Technical Service Bulletin: tsb100465

Released Date: 28-Apr-2006

Lubricating Oil Centrifuge Modification

Fig 1. New Radius on Balancing Notch.

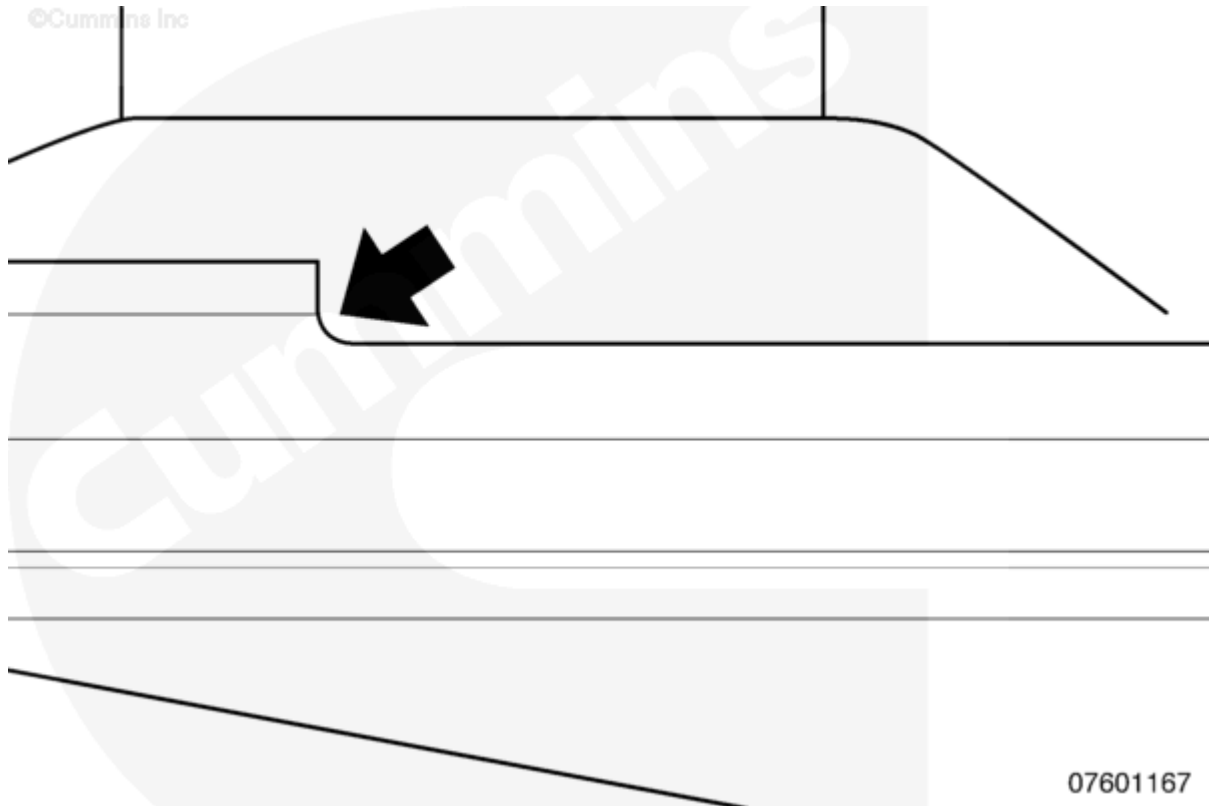
This Technical Service Bulletin details a modification carried out on the lubricating oil centrifuge (Fleetguard® Part Numbers 389497500S, CH4410500 and CH4412000), fitted on some QSK60 Construction series engines. To resolve an issue of high pressure spikes within the centrifuge and subsequent rotor cracking, the balance notch on the rotor turbine has been modified to include a radius which will lower the stresses and eliminate the cracking.

Fig. 2 and Fig. 3 show markings on modified centrifuge.

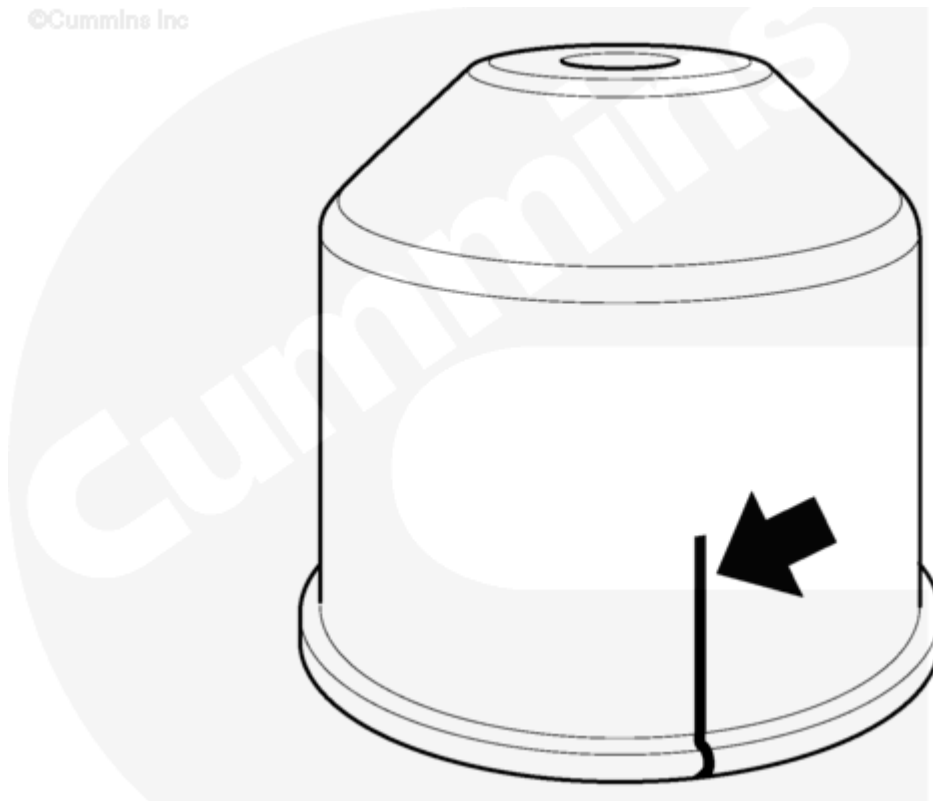
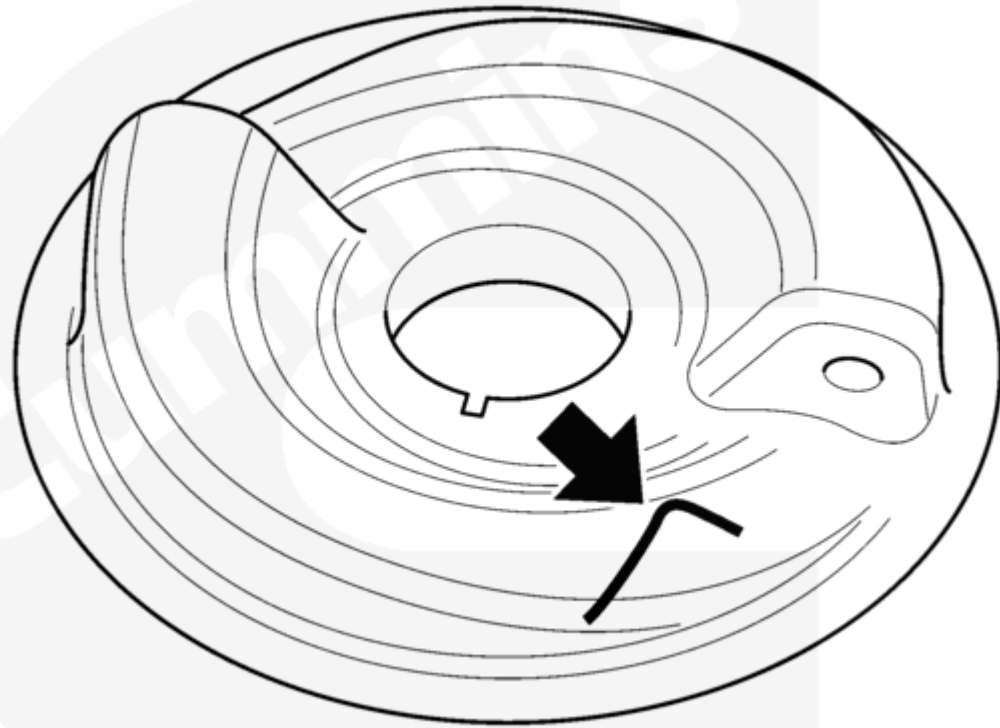
No part number change was required. Fleetguard® have marked all the present stock of modified rotor assemblies with a white line on the outside of the turbine can, as well as a white check mark on the bottom of the centrifuge.
